Access Compliance Report Public Rights-of-Way (Pedestrian Signals)

Main Street: **CHIQUITA_CANYON_DR** Cross Street: **N/A** Location: **SE**

ADA ID: **SGRK211124133458** Signal Type: **One Push Button-Non APS** Overall Compliance: **No** Severity Scores: **BTN 1: 35** **BTN 2: N/A** **No BTN: N/A**

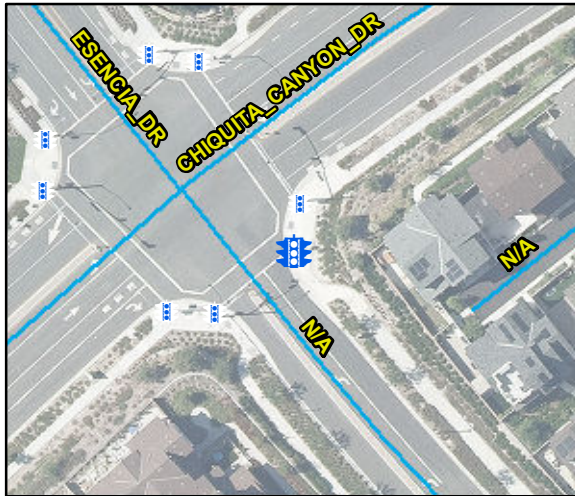
OC Std/PROW: R404.2, MUTCD 4e.08

Possible Solutions: Replace Signal Push Button With APS Button. Remove and Replace Clear Space.
